File No. 200996

### NOTICE TO BOARD OF SUPERVISORS OF APPEAL FROM ACTION OF THE CITY PLANNING COMMISSION

2001 37th Avenue, San Francisco, CA

X The Planning Commission approved in whole or in part an application for conditional use authorization, Case No. <u>2018-012648CUA</u>.

## Figure 14. Glare Impact Map

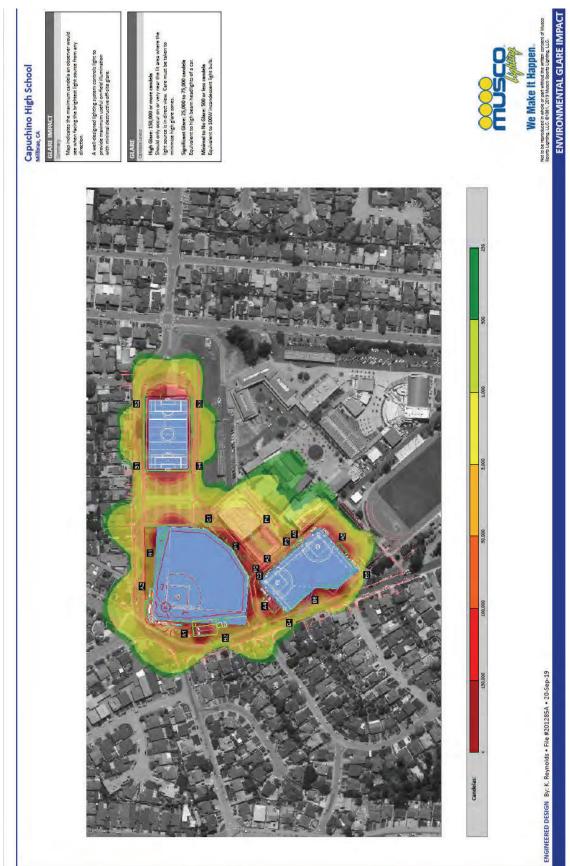
The glare impacts on adjacent residents would be limited to the areas shown in Figure 14, above. The figure indicates the maximum *calenda*, or amount of glare an observer would see when facing the brightest light source from any direction. *High glare* is considered to be 150,000 or more candela. *Significant glare* is defined as 25,000 to 75,000 candela, which is equivalent to the high beam headlights on a car. *Minimal to no glare* is 500 or fewer candela, or equivalent to a 100-watt incandescent light bulb. Figure 14 shows that the glare from the lighting that the residents adjacent to the softball and baseball fields would experience would be 5,000 candela or less, which is not considered a significant level of glare. Additional lighting diagrams are provided in Appendix B.

Figure 1: Photo rendition of 90-foot stadium lights [source: Saint Ignatius, 2015-014427PRV]

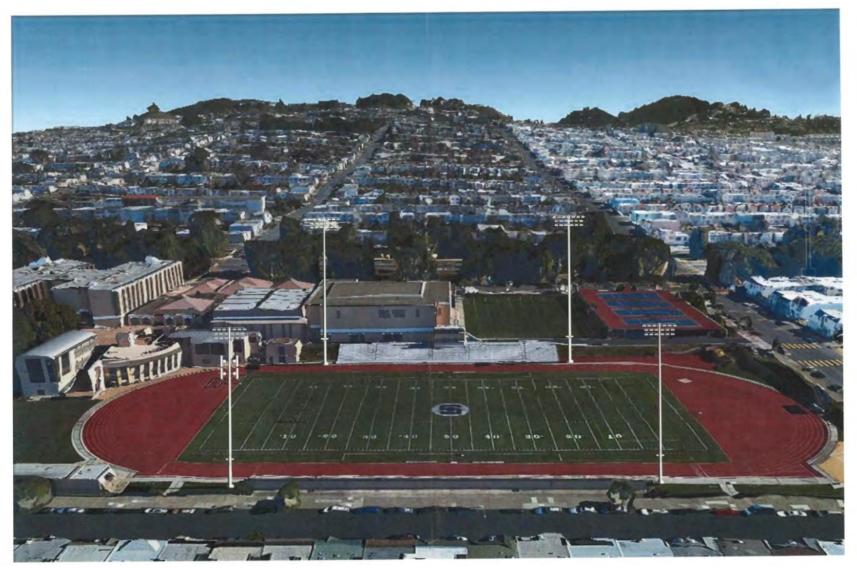
A 90-foot tall pole is equivalent in height to a 9-story building. Figure 1 is a photographic rendition of the proposed 90-foot tall lights prepared by the project proponent in the 2015 project description. The view is uphill toward the East with Sunset Boulevard (at the strip of trees) shown just beyond the athletic field and school buildings. There are no other tall structures in that view, and likewise there are no other tall structures when viewing downhill from the school toward the ocean. Appendix 1 provides three photographic renditions and two scale drawings created by SINA that show different views which further illustrates the relationship of a 90-foot tall pole to surrounding buildings and structures.

The proposed 90-foot poles would be, by far, the tallest structures in this part of the City, and would constitute a significant blight on the landscape, particularly for the surrounding neighborhoods and City visitors having a direct view of them. The adverse visual impact would be continual and most apparent during daylight even when the lights are not in use. The poles are so tall relative to houses that they would be visible from both the front and rear yards of all homes in the immediate neighborhood and from much farther away as well.

Figure 4: Scale Drawing of Stadium Lighting Poles

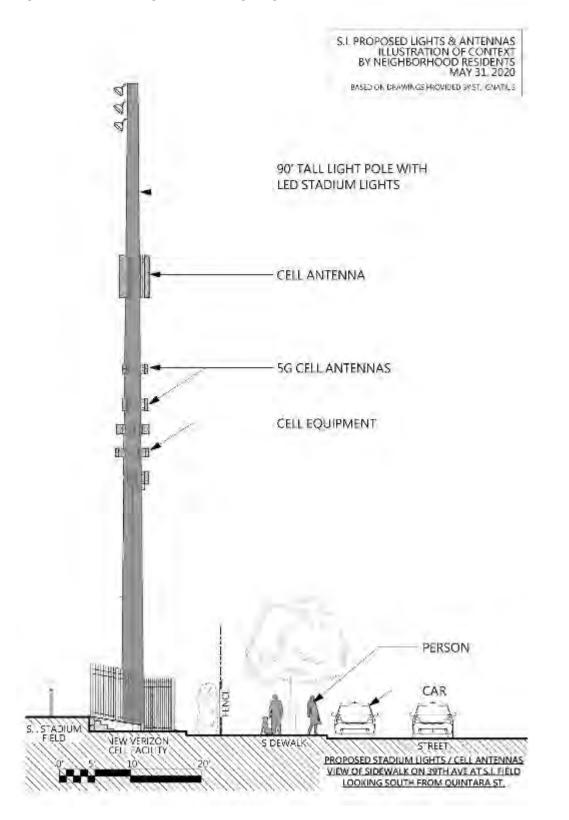
We continue to assert that new 90-foot tall poles with 12 to 13-foot wide lighting arrays (based on the Verizon scale drawings) reasonably constitute "unusual circumstances" in this location and that the project would result in the "reasonable possibility of a significant effect" on aesthetics(see also SINA submittal Comments 1.C and 3.A; and Figure 3 and Appendix 1 therein for images).

Since our prior submittal we have learned that wireless installations and light standards are exempt from the height restrictions in RH-1 districts under Code Sections 260(b)(I) and (J). However, 90-foot poles, whether for lighting or wireless facilities at this location would be grossly out of scale for this particular neighborhood (see Figures 2 and 3 above). Figure 4 below, created for SINA by a local architect, gives a sense of the relative scale of the poles to the surrounding area. Two of the four poles would be located directly inside the school's fence line as shown in the figure and would loom over the street and neighborhood at the height of a 9-story building.

Figure 3. Verizon Current Coverage Map (the project location is identified as Sunset & Noriega in the map center)

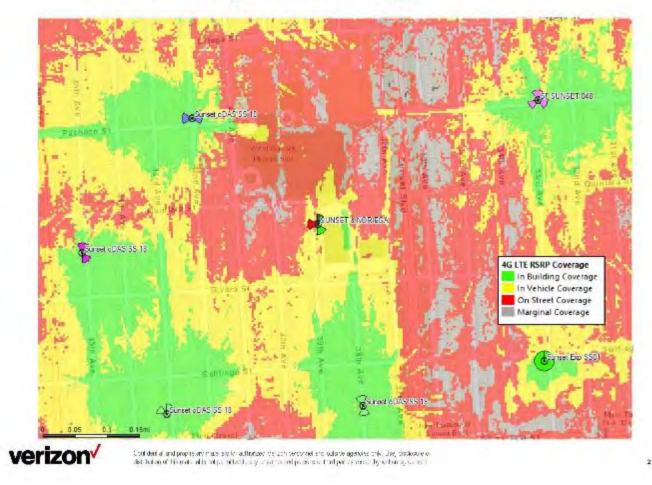
a) Again, the wireless project should be decoupled from the lighting project which does not provide benefits consistent with these policies. Furthermore, the proposed wireless coverage would provide these benefits only within a localized area where little business (other than possibly home-based business) occurs. The same is true for any benefits associated with the Community Safety Element. The current and proposed wireless coverage maps are shown in Figures 3 and 4 below and illustrate the limited extent of new or improved wireless coverage expected.

- c) Visitor Trade Policy 8.3 is also mis-applied in the draft motion since the policy states: "Assure that areas of <u>particular visitor attraction</u> are provided with adequate public services..." Even if applicable to just the Verizon wireless installation, there is no basis upon which to declare a private school athletic field a "particular visitor attraction" nor does the new wireless coverage enhance communications in areas of the City with specific visitor attractions (see Figure 4).

Figure 3. Verizon Current Coverage Map (the project location is identified as Sunset & Noriega in the map center)

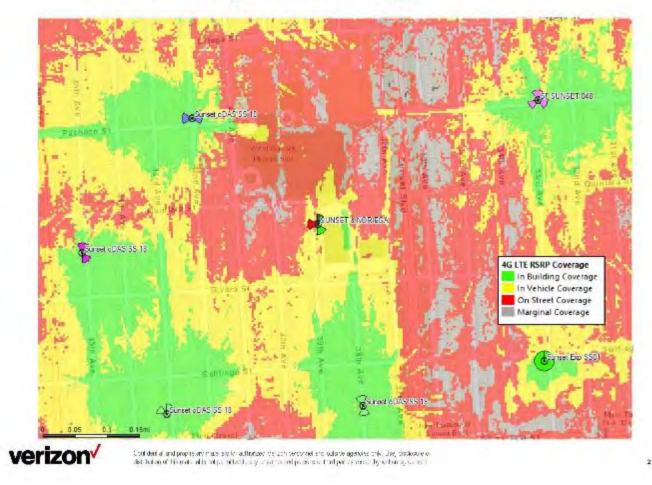
a) Again, the wireless project should be decoupled from the lighting project which does not provide benefits consistent with these policies. Furthermore, the proposed wireless coverage would provide these benefits only within a localized area where little business (other than possibly home-based business) occurs. The same is true for any benefits associated with the Community Safety Element. The current and proposed wireless coverage maps are shown in Figures 3 and 4 below and illustrate the limited extent of new or improved wireless coverage expected.

- c) Visitor Trade Policy 8.3 is also mis-applied in the draft motion since the policy states: "Assure that areas of <u>particular visitor attraction</u> are provided with adequate public services..." Even if applicable to just the Verizon wireless installation, there is no basis upon which to declare a private school athletic field a "particular visitor attraction" nor does the new wireless coverage enhance communications in areas of the City with specific visitor attractions (see Figure 4).

Figure 1: Photo rendition of 90-foot stadium lights [source: Saint Ignatius, 2015-014427PRV]

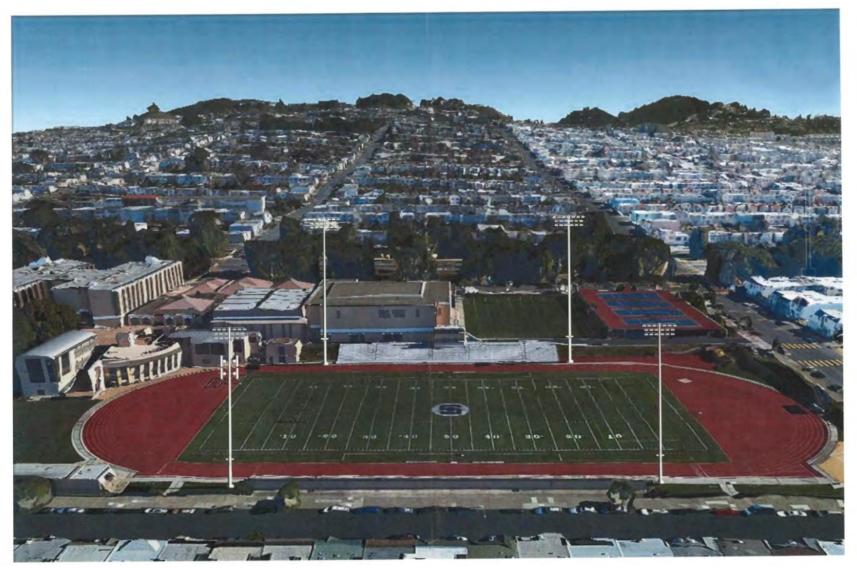
A 90-foot tall pole is equivalent in height to a 9-story building. Figure 1 is a photographic rendition of the proposed 90-foot tall lights prepared by the project proponent in the 2015 project description. The view is uphill toward the East with Sunset Boulevard (at the strip of trees) shown just beyond the athletic field and school buildings. There are no other tall structures in that view, and likewise there are no other tall structures when viewing downhill from the school toward the ocean. Appendix 1 provides three photographic renditions and two scale drawings created by SINA that show different views which further illustrates the relationship of a 90-foot tall pole to surrounding buildings and structures.

The proposed 90-foot poles would be, by far, the tallest structures in this part of the City, and would constitute a significant blight on the landscape, particularly for the surrounding neighborhoods and City visitors having a direct view of them. The adverse visual impact would be continual and most apparent during daylight even when the lights are not in use. The poles are so tall relative to houses that they would be visible from both the front and rear yards of all homes in the immediate neighborhood and from much farther away as well.

Figure 4: Scale Drawing of Stadium Lighting Poles

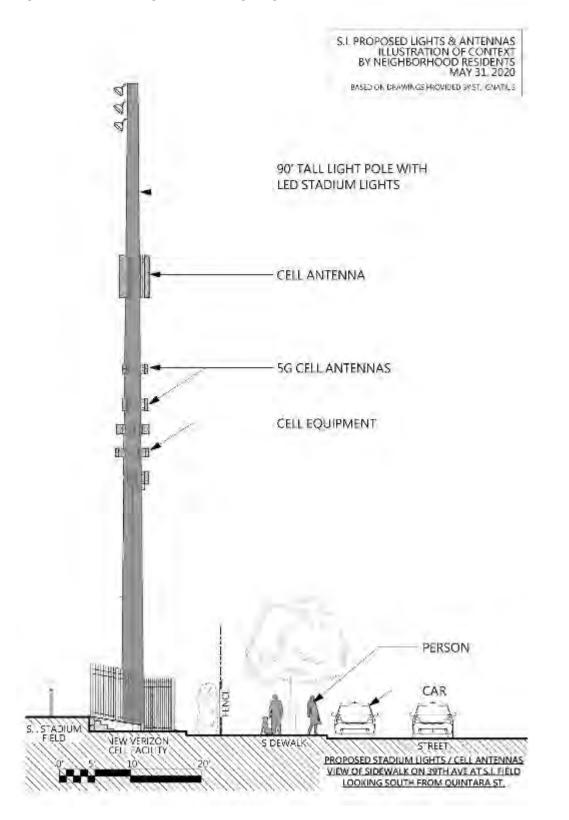
We continue to assert that new 90-foot tall poles with 12 to 13-foot wide lighting arrays (based on the Verizon scale drawings) reasonably constitute "unusual circumstances" in this location and that the project would result in the "reasonable possibility of a significant effect" on aesthetics(see also SINA submittal Comments 1.C and 3.A; and Figure 3 and Appendix 1 therein for images).

Since our prior submittal we have learned that wireless installations and light standards are exempt from the height restrictions in RH-1 districts under Code Sections 260(b)(I) and (J). However, 90-foot poles, whether for lighting or wireless facilities at this location would be grossly out of scale for this particular neighborhood (see Figures 2 and 3 above). Figure 4 below, created for SINA by a local architect, gives a sense of the relative scale of the poles to the surrounding area. Two of the four poles would be located directly inside the school's fence line as shown in the figure and would loom over the street and neighborhood at the height of a 9-story building.
